**BRADBURY PLACE TOWNHOMES**  
A PORTION OF SECTION 3, TOWNSHIP 19N, RANGE 04 E, W.M.  
CITY OF PUYALLUP, PIERCE COUNTY, WASHINGTON

SHEET TITLE: COVER SHEET AND HORIZONTAL CONTROL

PROJECT:	20-223
DWG NAME:	20-223 C
SHEET	REV.
C1	0
1 OF 28

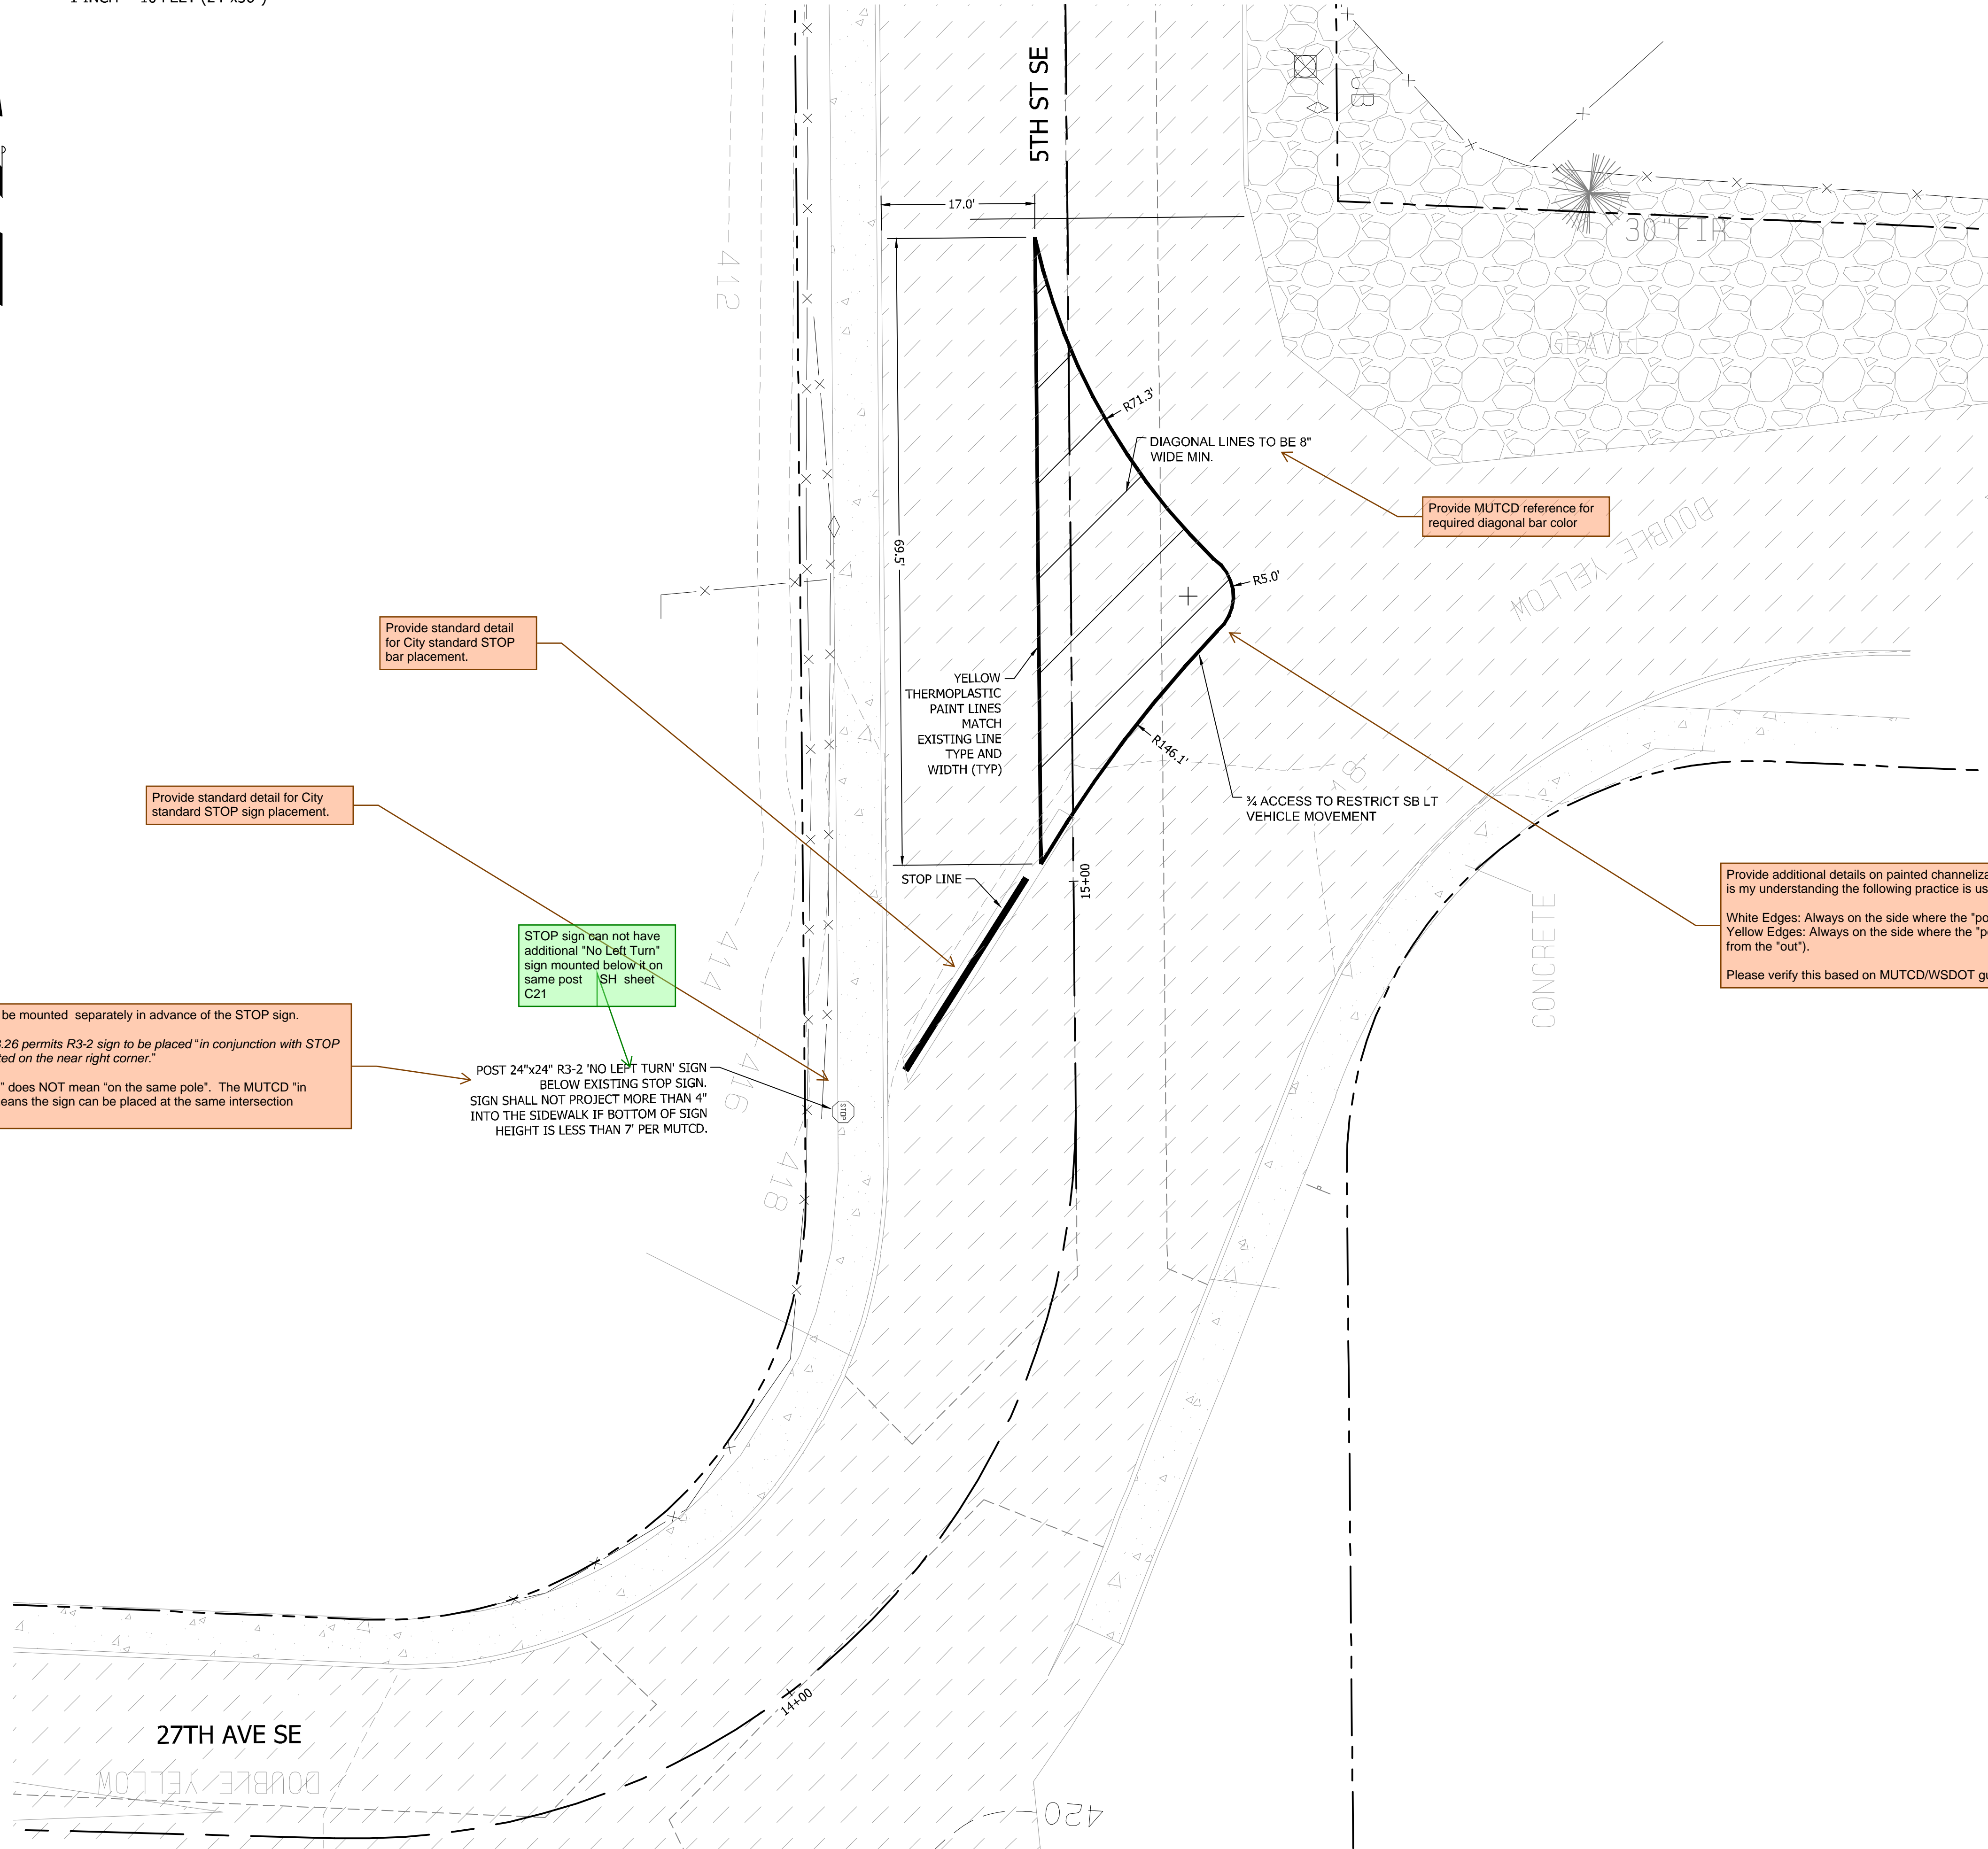
STOP sign can not have additional "No Left Turn" sign mounted below it on same post (SH sheet C21)
